**Brooks County High School and Junior High
Field House Plumbing Upgrades.**

ADDENDUM NO. 1

ADDENDUM NO. 1

DATE: July 02, 2025
Project: Falfurrias HS and JrH Fieldhouse Plumbing Upgrades
Project #: 25v51
To: David Monreal, GMS

EP4.01

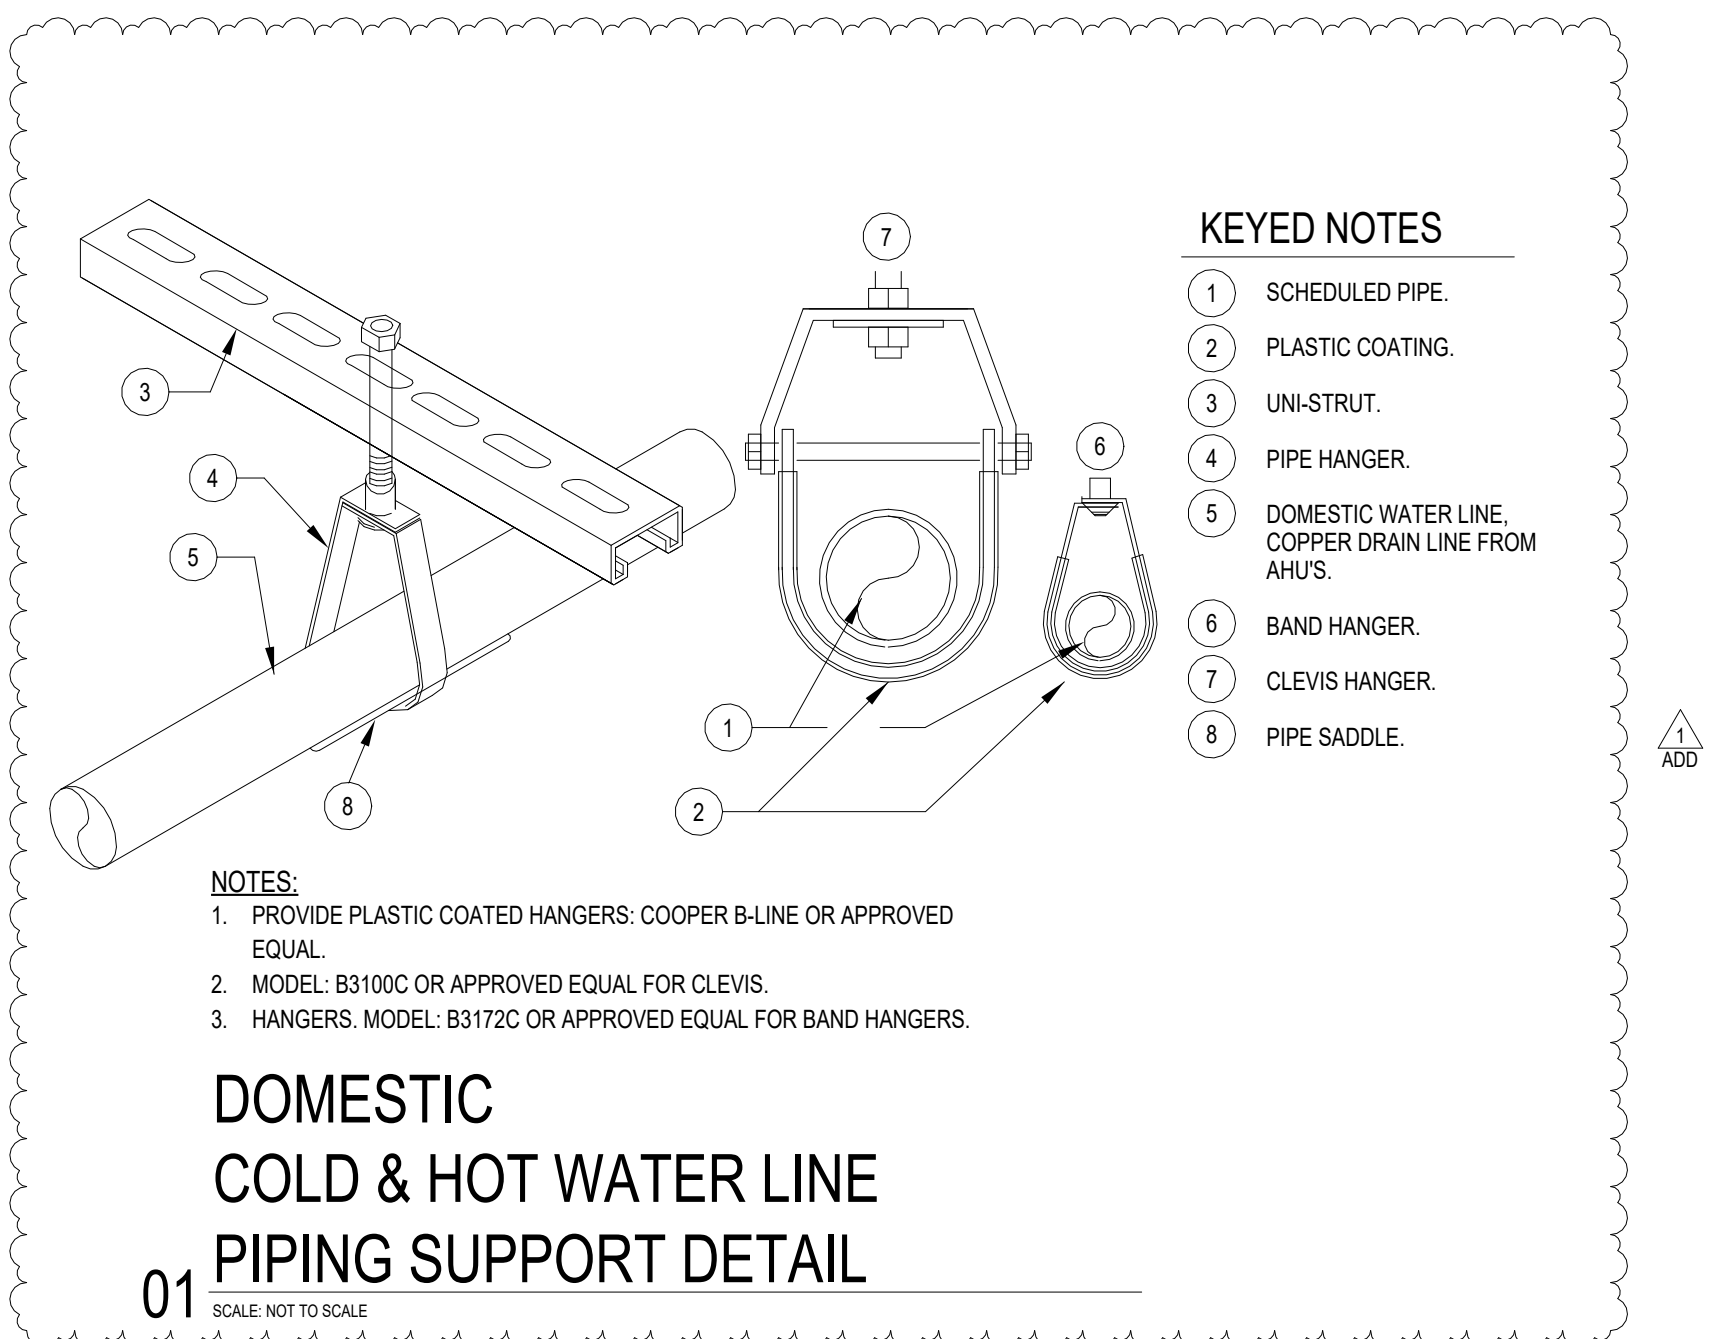
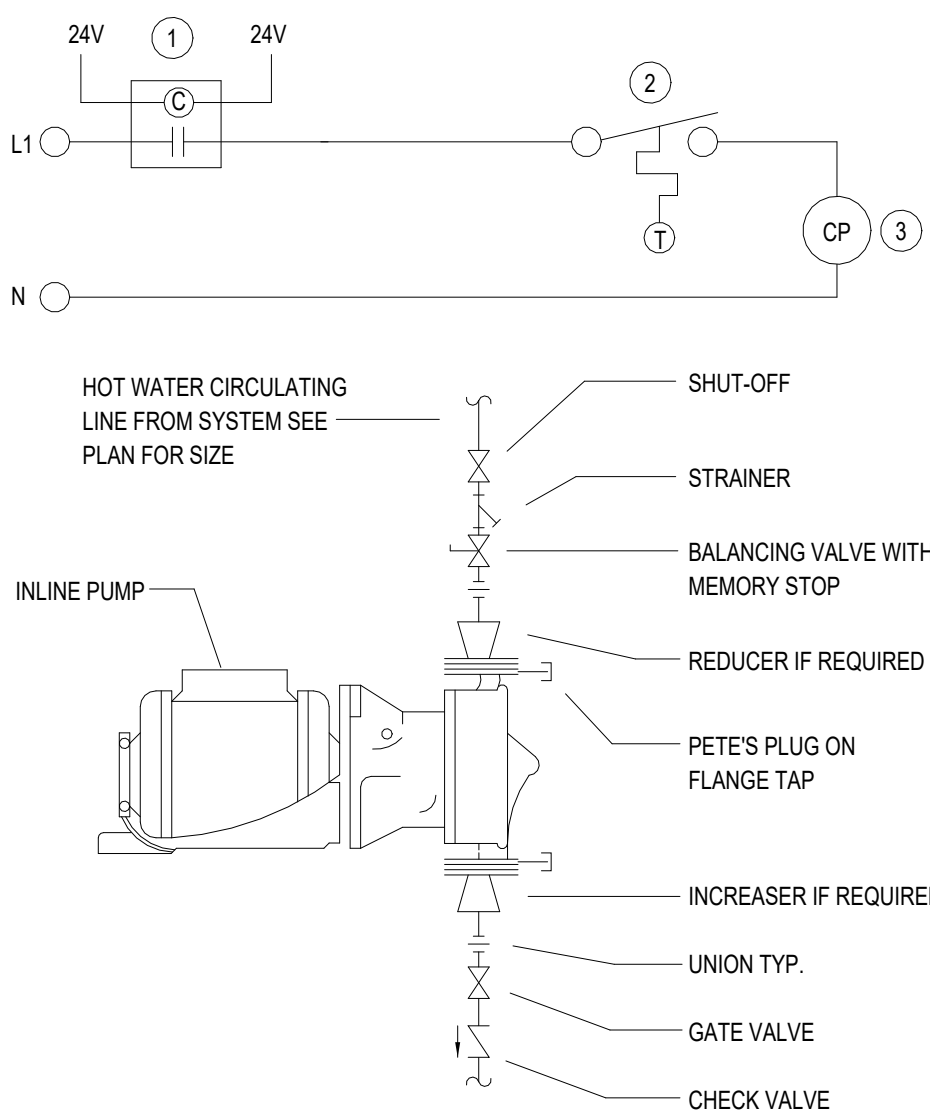
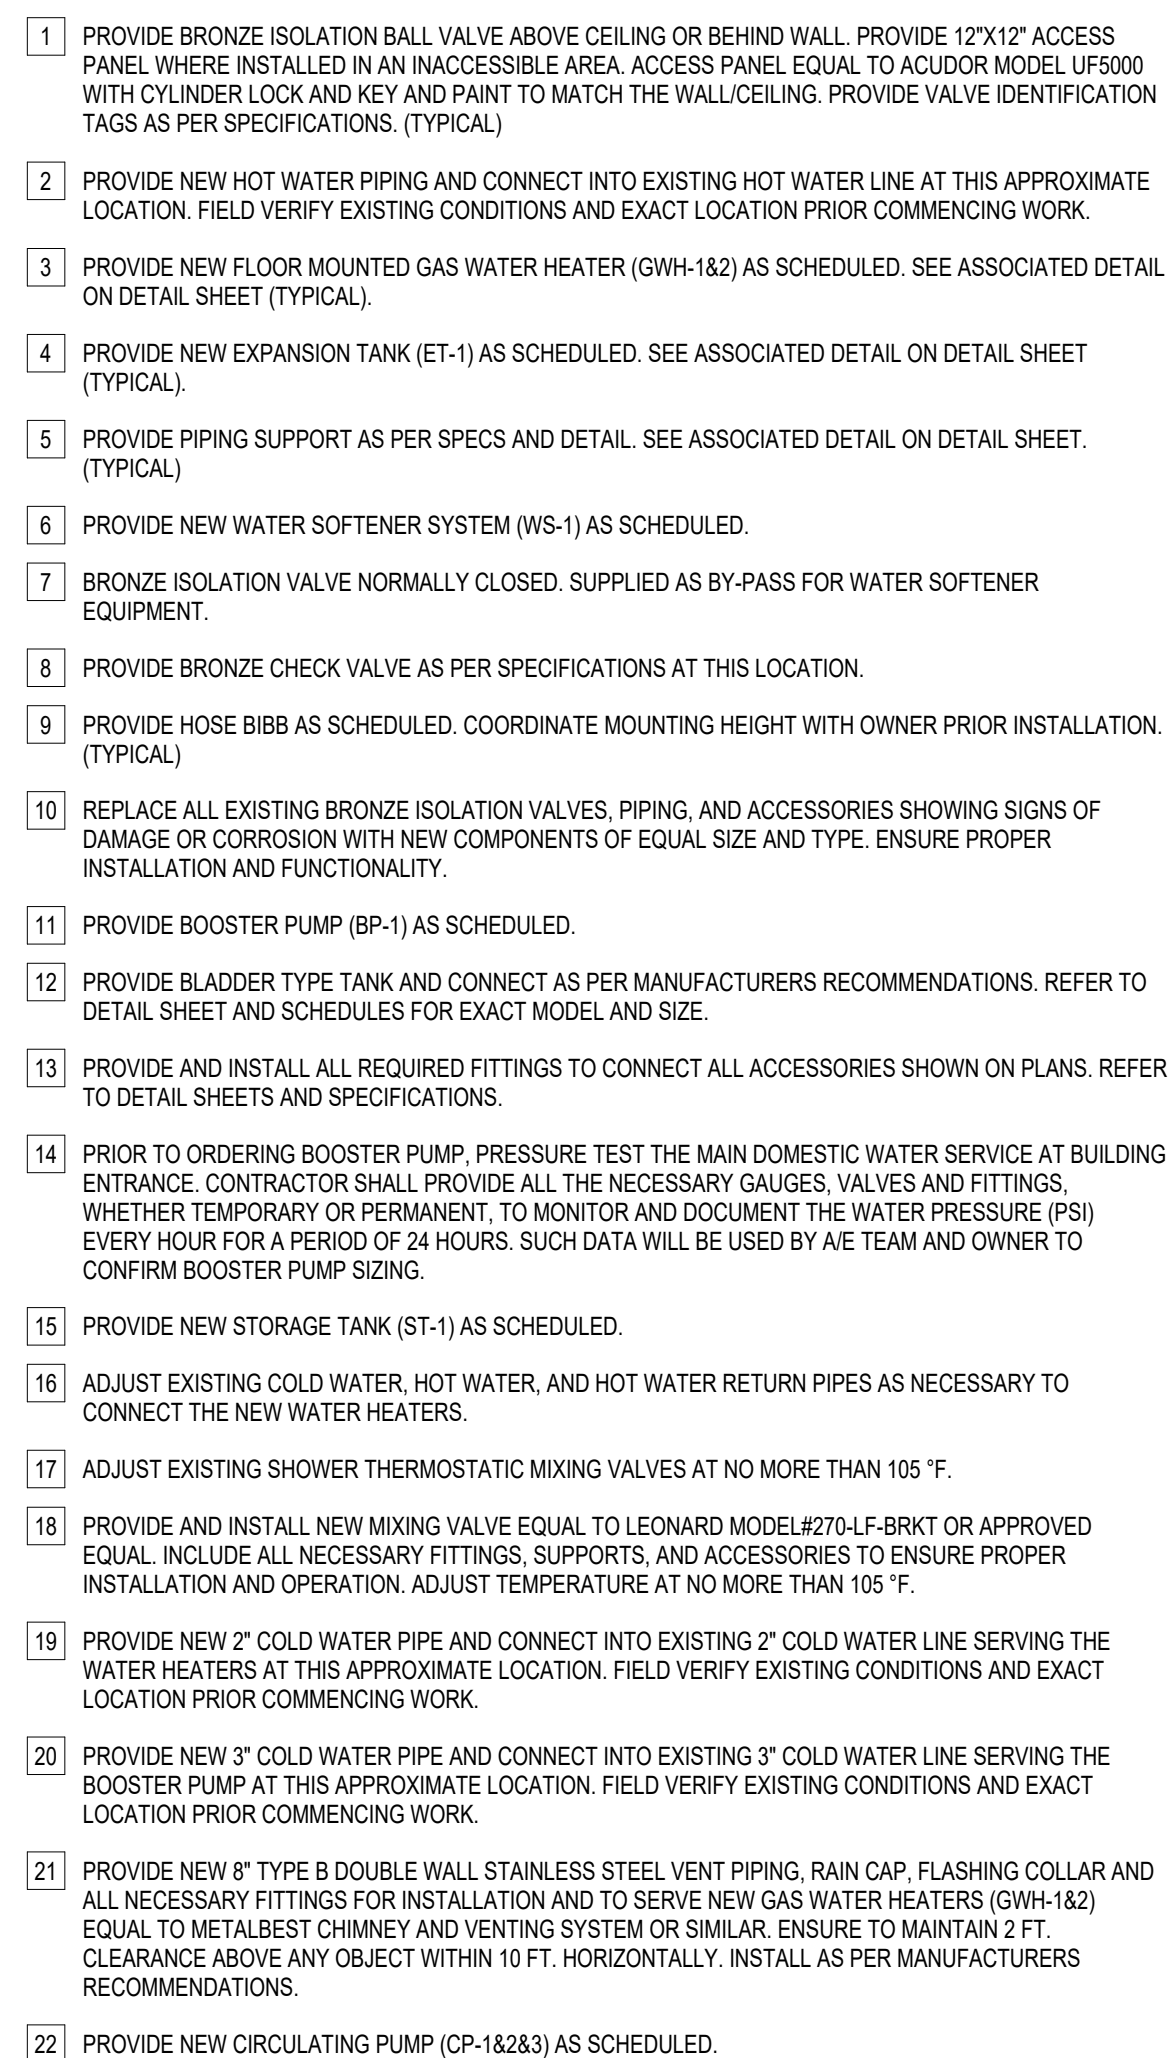
1. Sheet DEP2.01:
 - a) Revised Electrical and Plumbing Demolition Plan. See attached sheet.
2. Sheet DEP2.02:
 - a) Revised Electrical and Plumbing Demolition and Renovation Plan. See attached sheet.
3. Sheet EP3.01:
 - a) Revised Electrical and Plumbing Renovation Plan. See attached sheet.
4. Sheet EP4.01:
 - a) Revised Electrical and Plumbing Schedules and Details. See attached sheet.
